Geraldton Southern Transport Corridor

**Report and Recommendations
of the Environmental Protection Authority**

**Environmental Protection Authority
Perth, Western Australia
Bulletin 1013
May, 2001**

Assessment No. 1375

Figure 3. Vegetation and topography (Source: Connell Wagner Pty Ltd, November 2000).

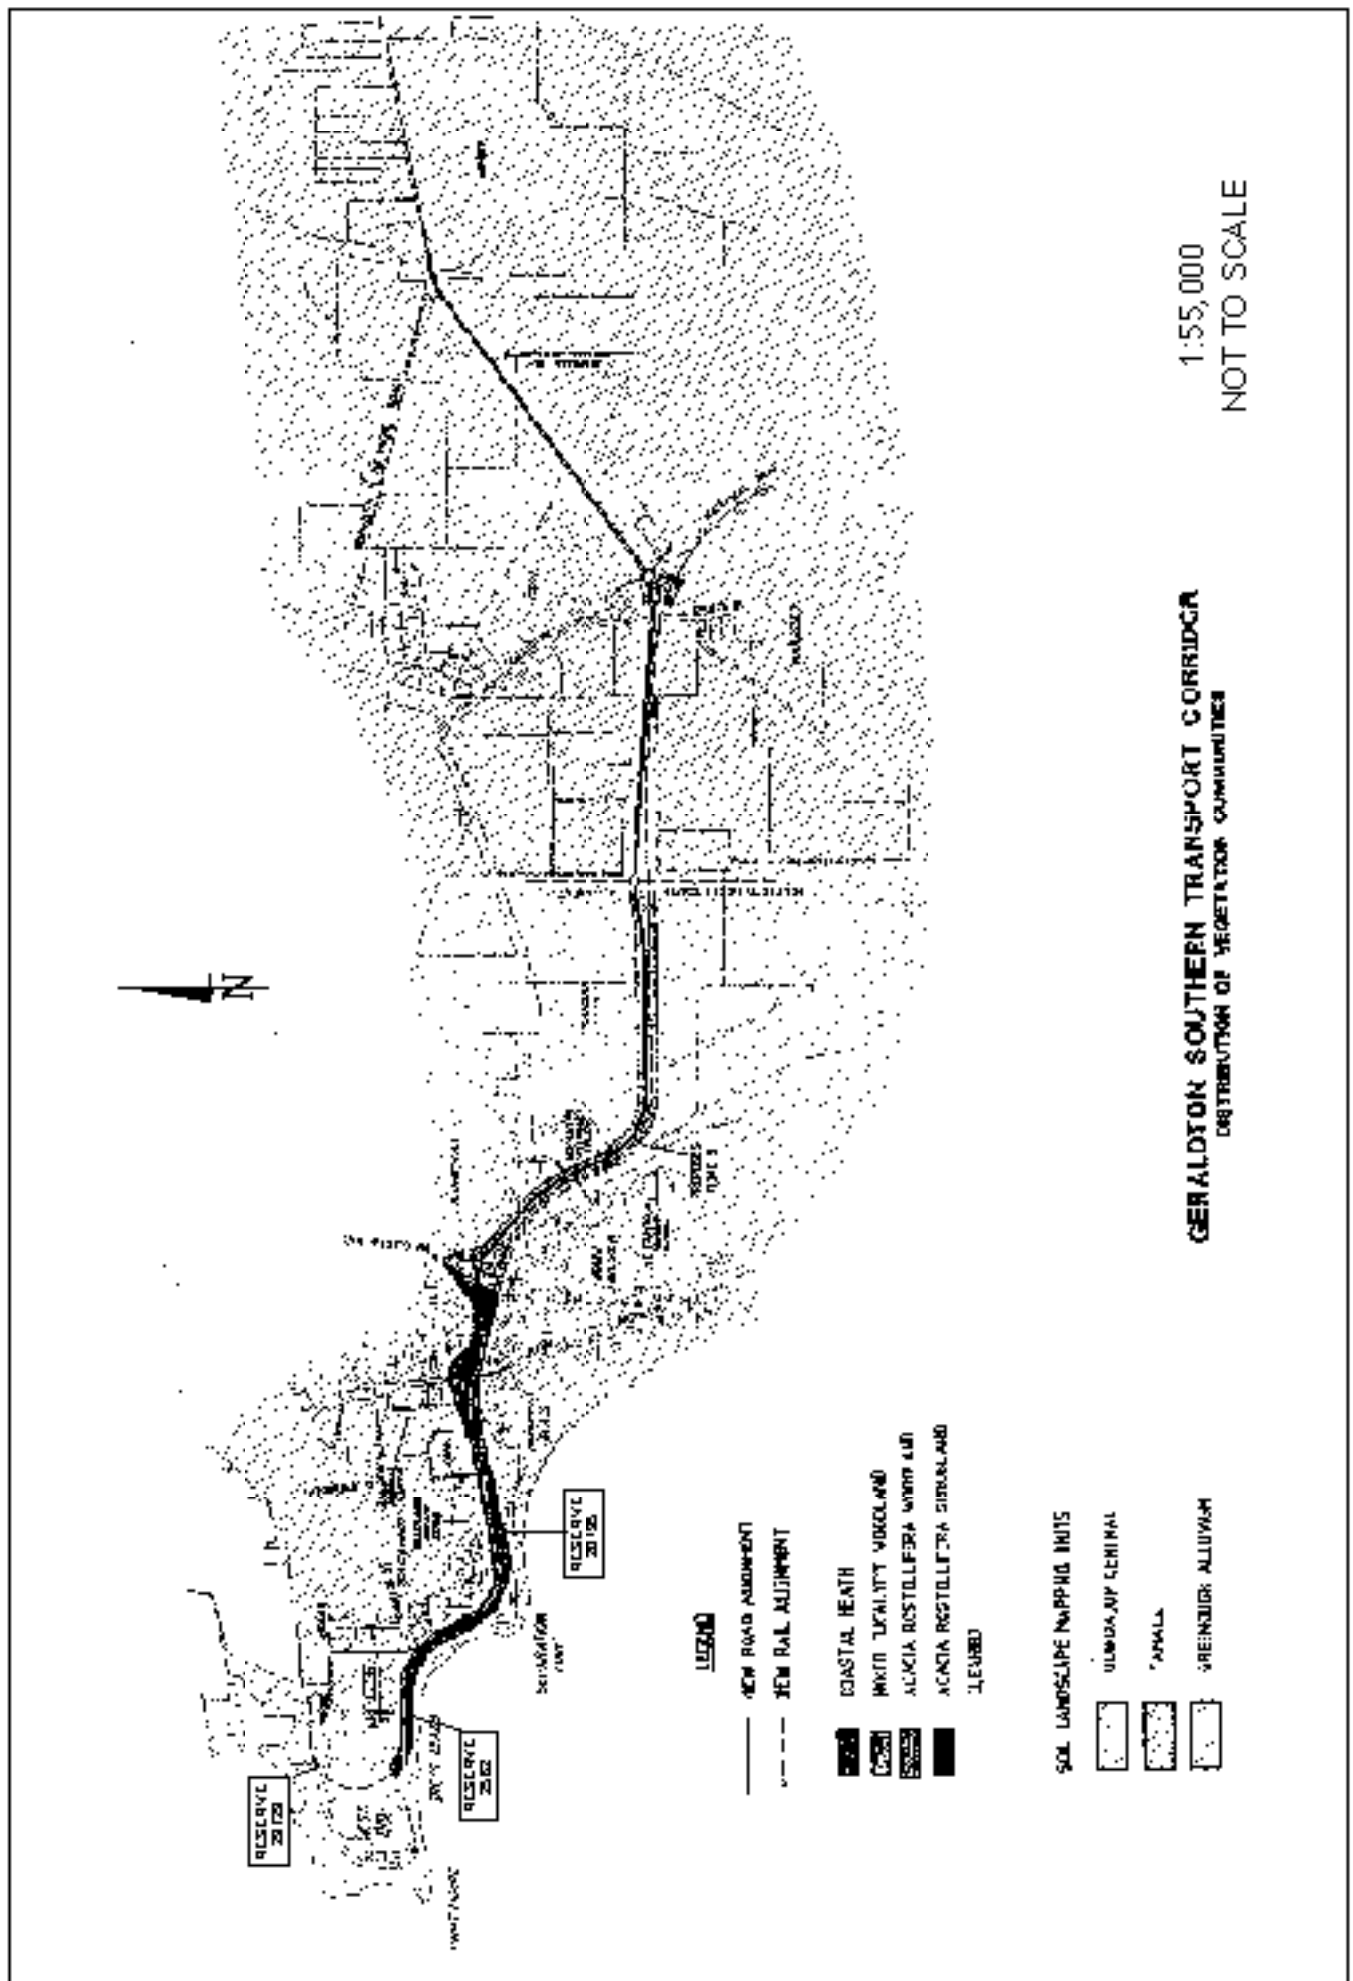
The location of the project has the potential to affect the erosion-accretion cycle if disturbance of the foredunes occurs during project construction. The potential worst case scenario for beach erosion is in the vicinity of the Grey's Beach (Figure 3).

In correspondence to MRWA, the Department of Transport (DoT) has recommended that the proposal maintain a setback of not less than 74m from the shore vegetation line. MRWA has revised the project to be consistent with this advice.

DoT has also accepted that there are significant difficulties in further reducing the radius of curvature of the rail line to increase the setback from the foredunes. To this end DoT has indicated that a design where the centre line of the rail component of the proposal is no closer than 74m from the shore vegetation line would be acceptable. Further, DoT has indicated that discharge of runoff directly onto the active beach face would be considered unacceptable due to the potential for damage.

MRWA has provided a commitment to ensure the placement of the proposal is beyond the coastal development zone buffer. This commitment will be implemented on the advice of the Maritime Branch of the DoT through revision of the road/rail alignment prior to the commencement of the design phase.

Figure 4. Sensitive Facilities (Source: Connell Wagner Pty Ltd, November 2000).

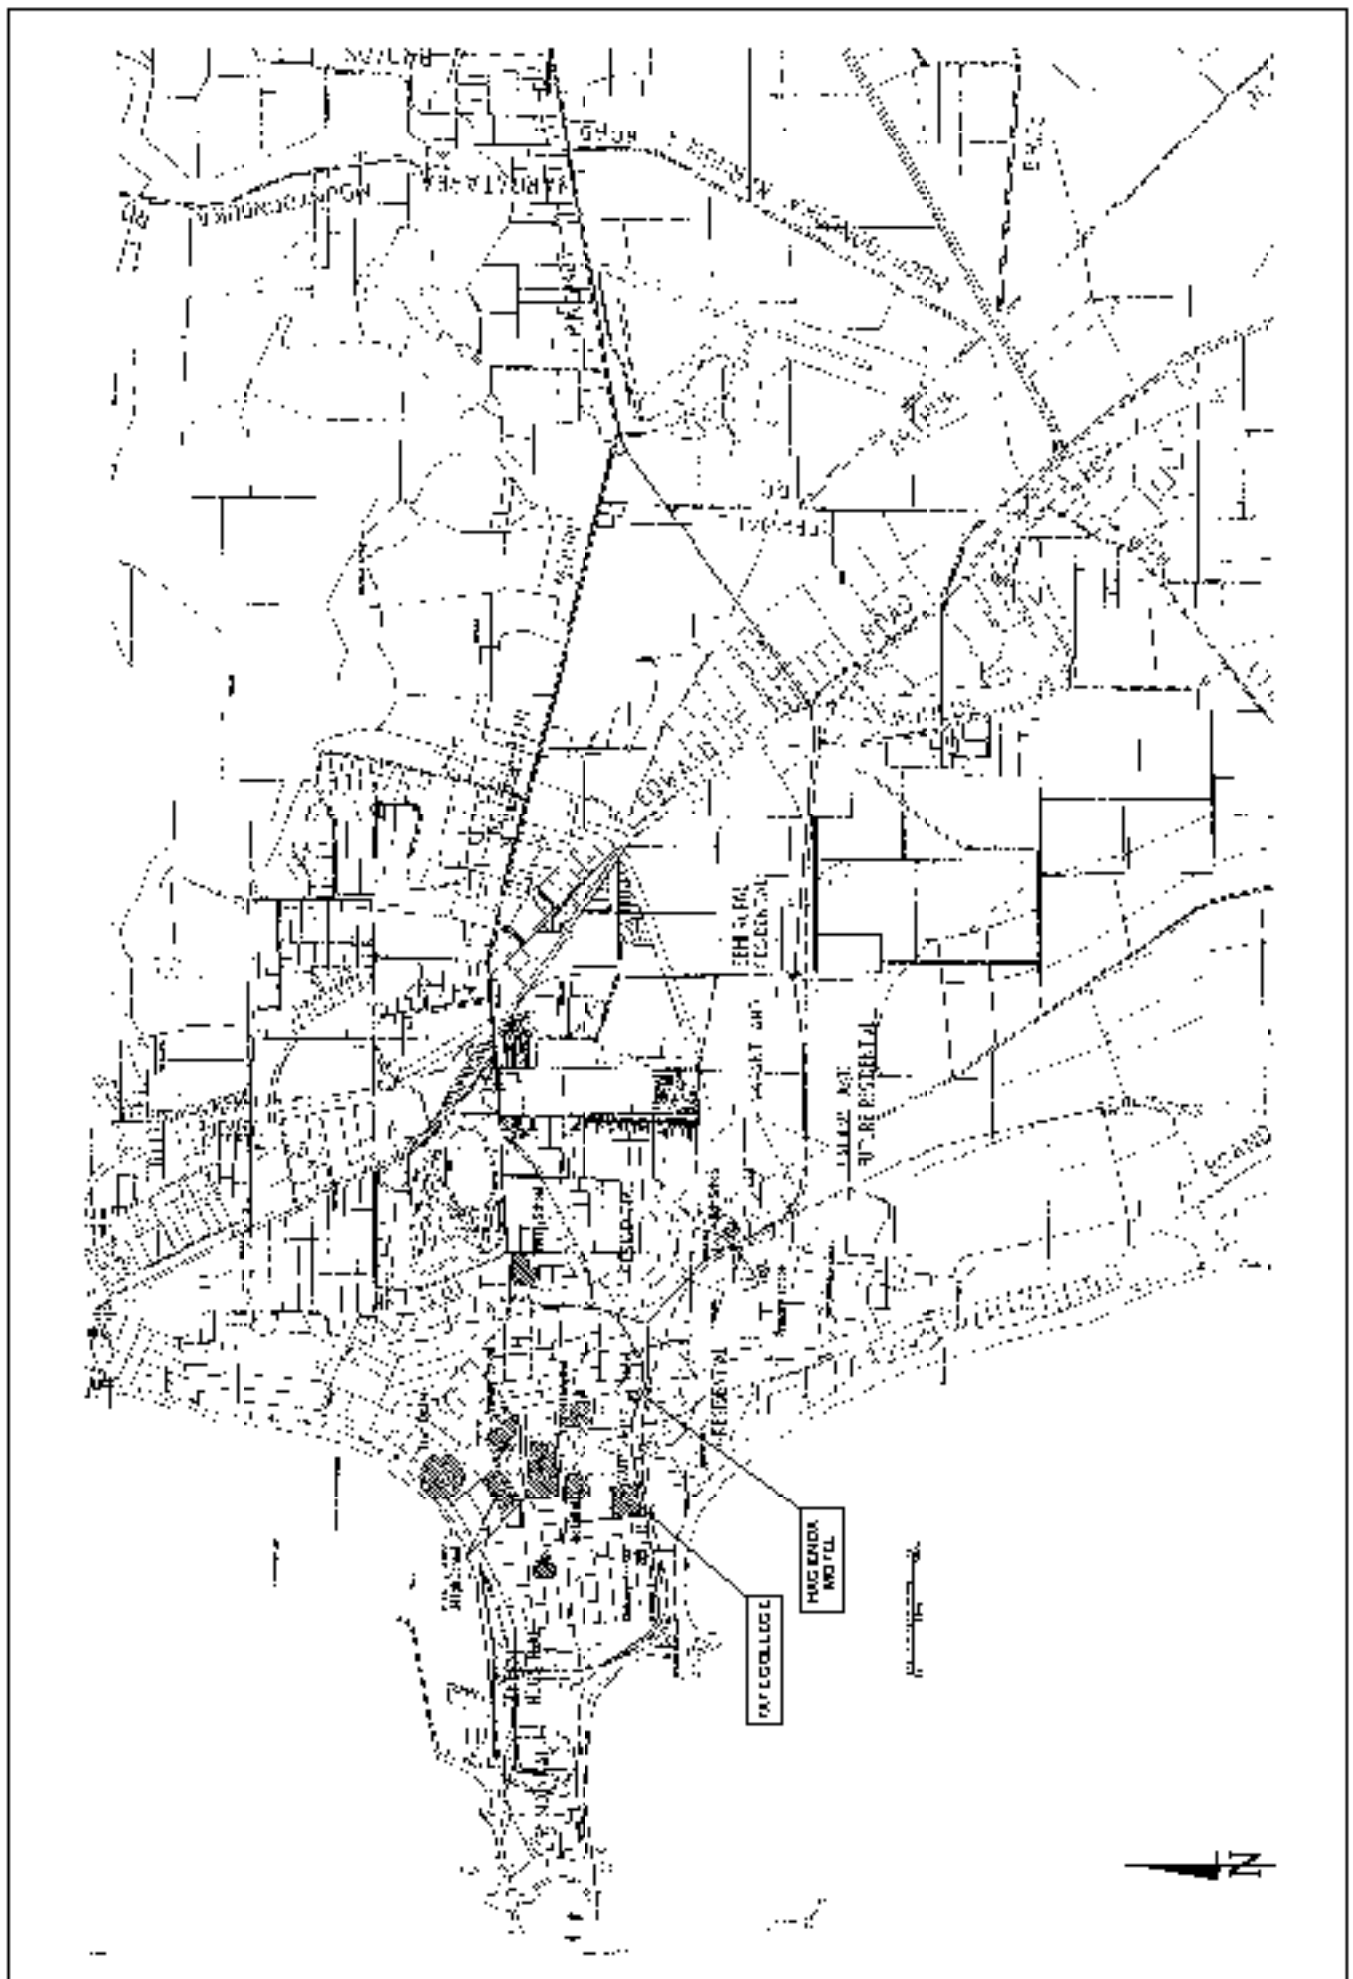
4. the most significant areas likely to be affected are the residential area and motel 10 metres from the GSTC On Ramp (East), and the TAFE campus at the corner of Portway and Fitzgerald Street (Figure 4); and

5. all residential areas and sensitive facilities lie below the EPA's criteria for individual risk. For societal risk, the sensitive facilities that lie between the bounds of negligible risk and intolerable risk are the Hacienda Motel and the TAFE facility. Both will require further actions to reduce the risk to below the upper bound of negligible risk.

MRWA has provided commitments to reduce levels of risk associated with the transport of dangerous goods to a level that is as low as reasonably practical. To achieve this level MRWA will:

- Construct basins with a capacity of 100m³ and an impermeable liner to capture contaminants prior to discharge to infiltration basins in zones of environmental threat;
- Advise emergency services of basin location and operation;
- Provide turn pockets and storage for turning vehicles in the median at the Fitzgerald Street intersection;
- Construct a noise barrier adjacent to the TAFE campus to provide additional blast protection; and
- Reduce societal risk to as low as reasonably practical in the vicinity of the On Ramp (East).
